Item Name: 205 Skidtube bent detail

DRAWING NO. D2580	TITLE 205 SKIDTUBE ASSEMBLY	REV. D	DART AEROSPACE LTD ENGINEERING ORDER		D.E.O. NO. D2580-D-1	SHEET NO. SHEET 1 OF 1	SCALE NTS
DRAWN <i>UP</i>	CHECKED <i>L</i>	MFG. APPR. <i>E</i>	APPROVED <i>MP</i>		DE APPR. <i>#</i>		
DATE 10.09.22	DATE 10.11.04	DATE 10.11.04	DATE 10/11/04		DATE 10.11.04

PURPOSE:

CHANGE ALL WELDED CROSSBOLT SPACERS TO SWAGED SPACERS

SECTION D-D & SECTION H-H ARE AMENDED AS FOLLOWS:

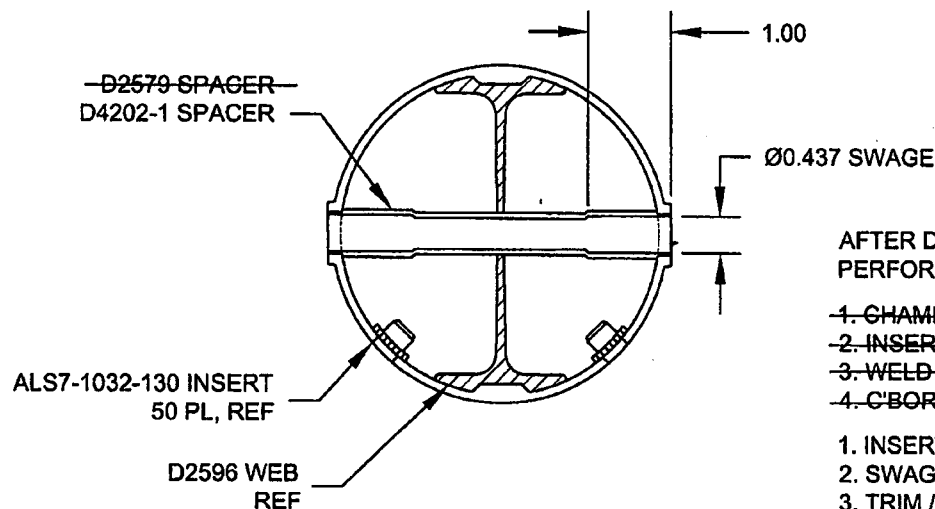
PARTS LIST IS AMENDED AS FOLLOWS:

QTY	QTY	PART NUMBER	DESCRIPTION
-041	-045		
20	24	D2579	CROSS BOLT SPACER

20	24	D4202-1	SPACER
----	----	---------	--------

AFTER DRILLING AND BENDING ASSEMBLY
PERFORM THE FOLLOWING FOR Ø0.508 HOLES ONLY:

1. CHAMFER HOLE 0.050 X 45°
2. INSERT D2579 SPACER (20 PLACES)
3. WELD INTO PLACE AND GRIND FLUSH
4. C-BORE D2579 SPACER TO Ø0.437 X 1.00 DEEP

1. INSERT D4202-1 SPACER, 20 PL (-041) OR 24 PL (-045)
2. SWAGE TO Ø0.437 X 1.00 DEEP PER QSI 002
3. TRIM / GRIND FLUSH PER QSI 002
